Passive Fire Protection Review

Site: Cestrian Court (11358)
Address: Newcastle Road,
Chester Le Street,
Durham,
DH3 3TD
Client: FirstPort
Visit Date: 9th July 2020
Author: Joe Nims BSc Hons
Review Date: N/A

Diagram of construction of CCDs showing void created by dab and daub method of affixing plasterboard walls.

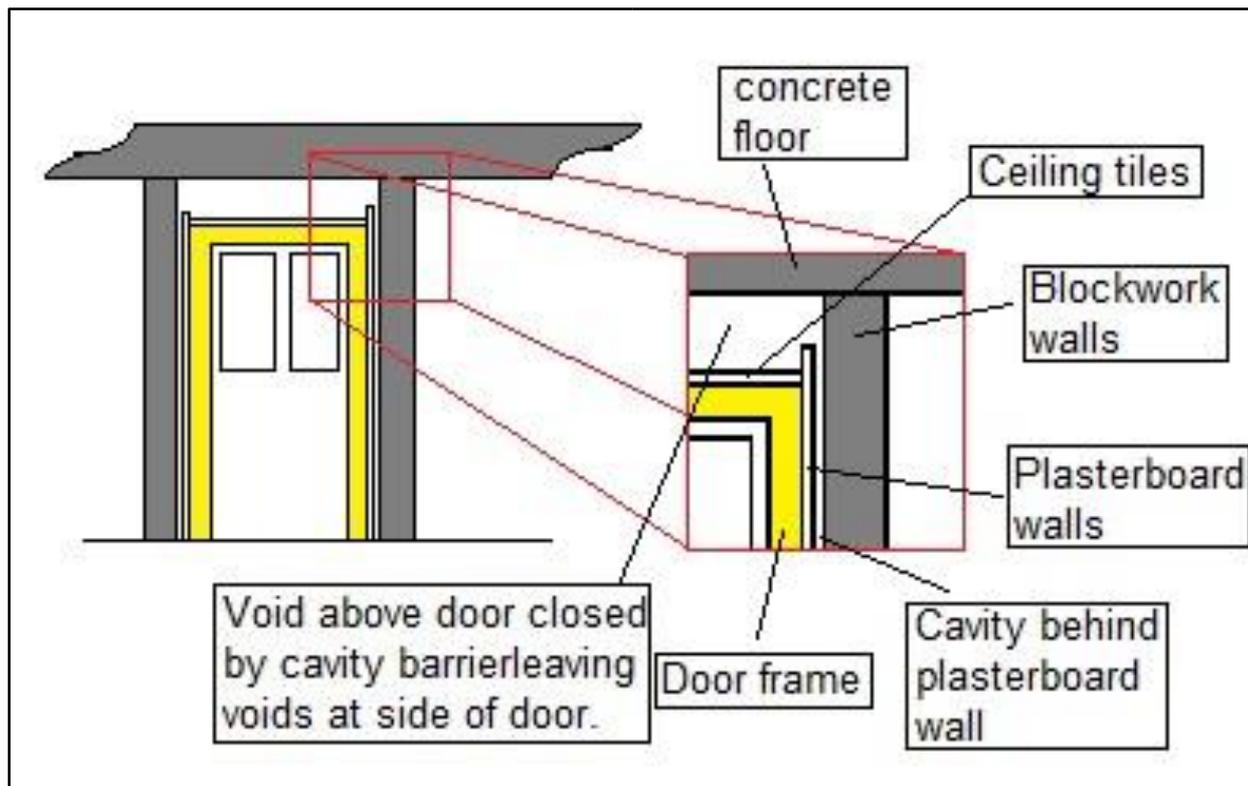
Cross corridor doors frames were attached to corridor plasterboard walls which were mounted on dab and daub method which creates a void behind plasterboard walls which by-passes cross corridor doors.

<p>Due to the use of the dab and daub method of affixing plasterboard sheets to blockwork walls in communal areas and cross corridor fire door frames were mounted to the plasterboard walls rather than the blockwork wall beneath there were voids by-passing the cross corridor doors (These voids were also open to the ceiling void).</p> <p>This defect is considered not to have met the guidance at the time of construction.</p>	<p>plaster for the voids behind board either: walls to be sealed by</p> <ul style="list-style-type: none"> a) Firestopping of plasterboard walls to blockwork wall in ceiling void of corridors to a 30 minute fire resisting standard using intumescent mastic. b) Cutting of plasterboard at cross corridor doors and the insertion of a timber batten at least 38mm thick affixed to the blockwork wall. <p>Note: re to the ceiling tiles requiring d mounted to seal all tions from ceiling void to flats w), option A above will (y be the best option.</p>	<p>3</p>

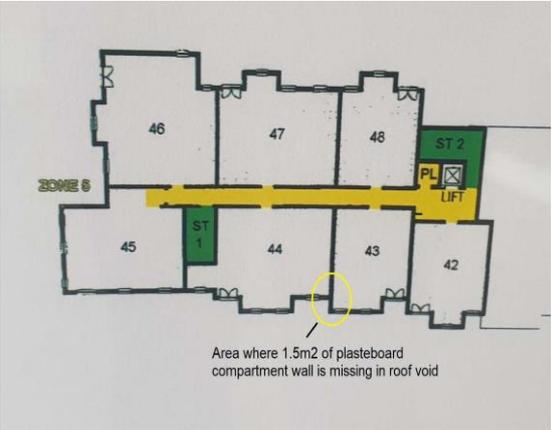
<p>Approximately 1.5m² of the compartment wall separating flats 42 and 43 was missing at the architectural detail at the elevation facing onto the main road.</p> <p>This defect is considered not to have met the guidance at the time of construction.</p>  <p>View from flat 43 into roof void of flat 44.</p>  <p>Location of missing compartment wall</p>	<p>Arrange for compartment wall to be installed between flats 44 and 43 to a minimum fire resistance of 60minutes.</p>	<p>1</p>
--	--	----------

SECOND FLOOR

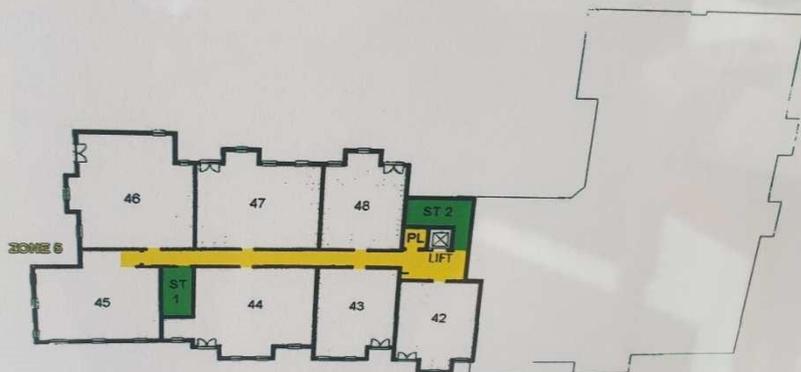
Due to the cost effectiveness of remediating all the defects in roof voids at once, i.e. Year 1 & 2 action plan (see defects above and below relating to loft spaces); all defects in loft spaces may be addressed at the same time:- loft spaces above flats 42 to 48 in year 1 and those above 26-34 in year 2, i.e. 2nd floor lofts in year 1 and 1st floor lofts in year 2. Year 3 actions will remain the same.

Alternative Year 1 loft areas flats 42 – 48 and staircase.

FIRST FLOOR

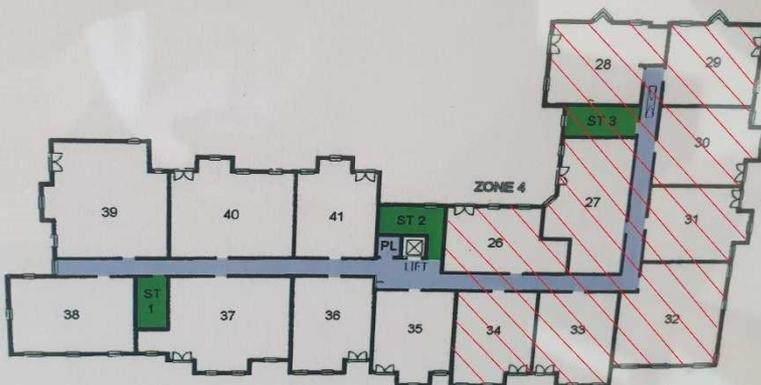
Alternative Year 2 loft areas shown hatched in red.
